AMENDED PLAN

PROPOSED SWIMMING POOL STRUCTURAL DETAILS
FOR F Van Dyk
AT 13 Manly Road, SEAFORTH

DATE: 14/10/08	SHEET 1 OF 7
DRAWN: OL-8135	
DRAWING/CONTRACT No. BHP 08L16374

SITE PLAN

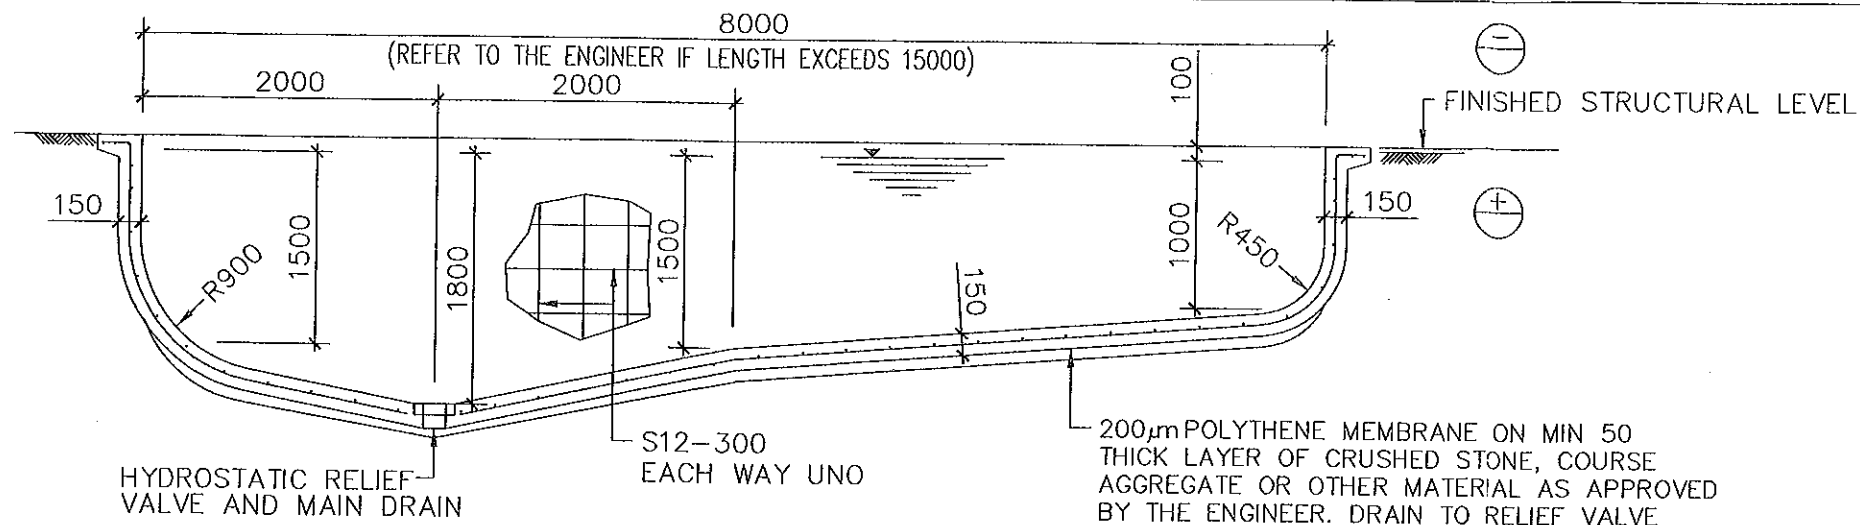
AMEND A	14/11/08	Filter Relocated
AMEND B	17/11/08	Proposed Retaining Walls Removed
AMEND C	06/03/09	Pool moved 800mm towards Street
AMEND D	10/09/09	Pool Redesigned & Relocated

PROPOSED SWIMMING POOL STRUCTURAL DETAILS

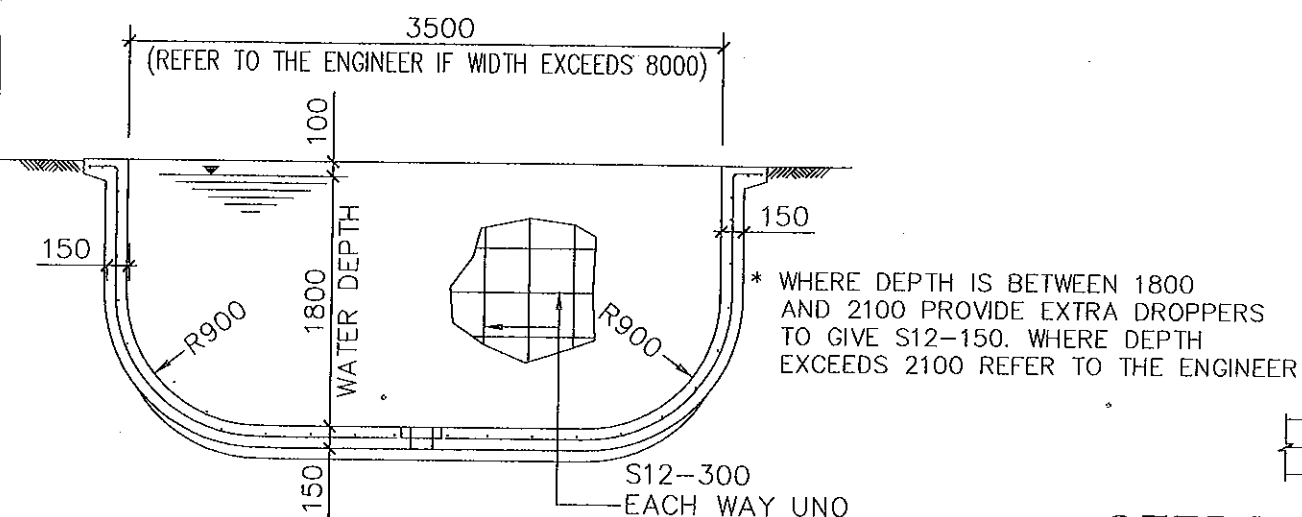
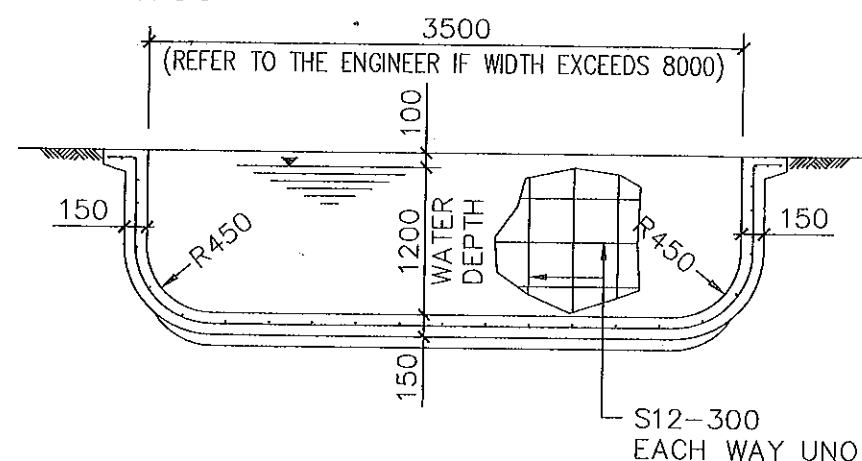
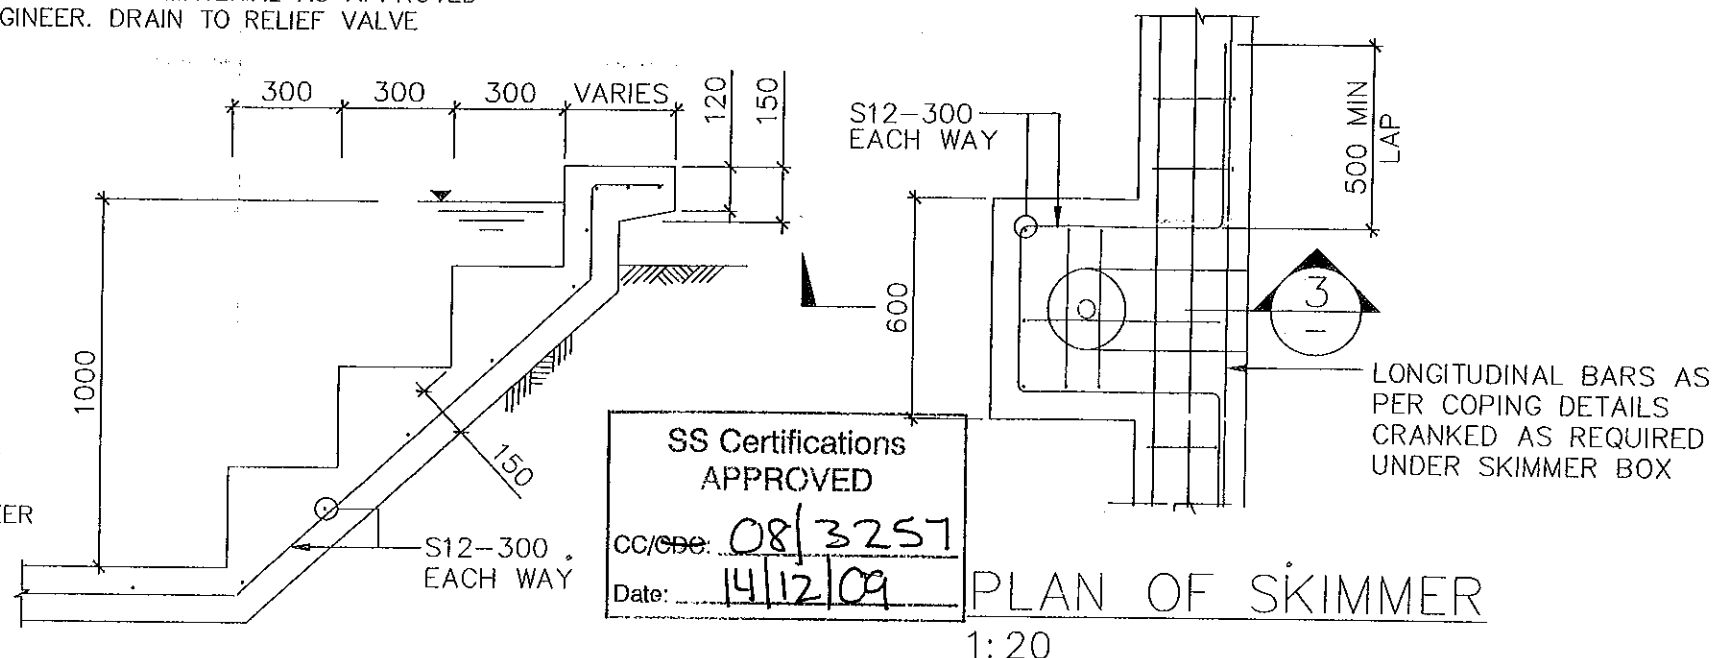
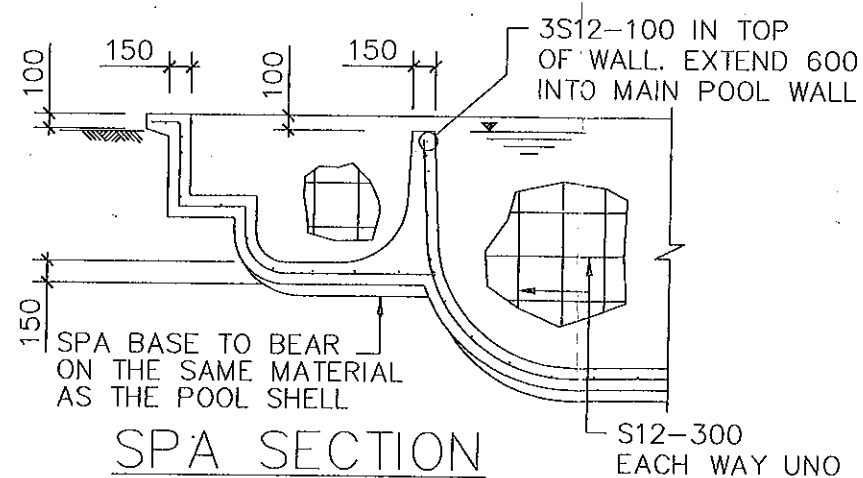
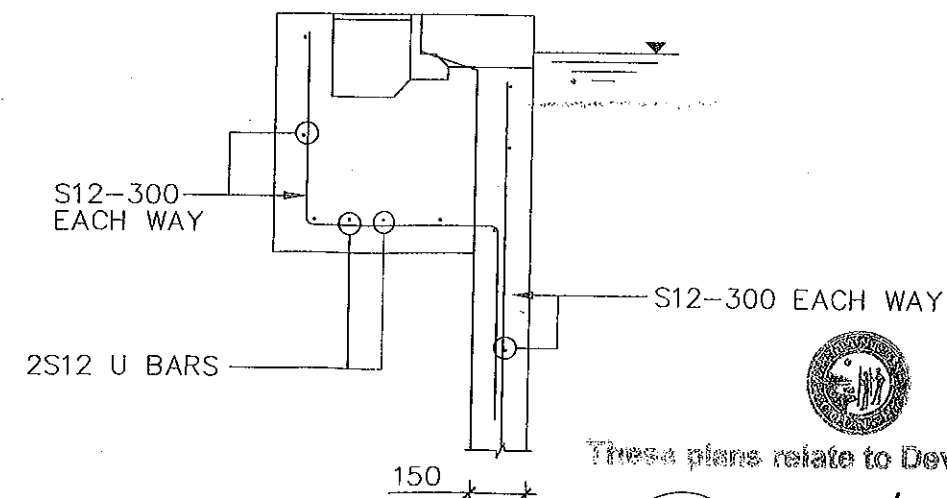
AMEND D 10/09/09

Pool Altered & Relocated
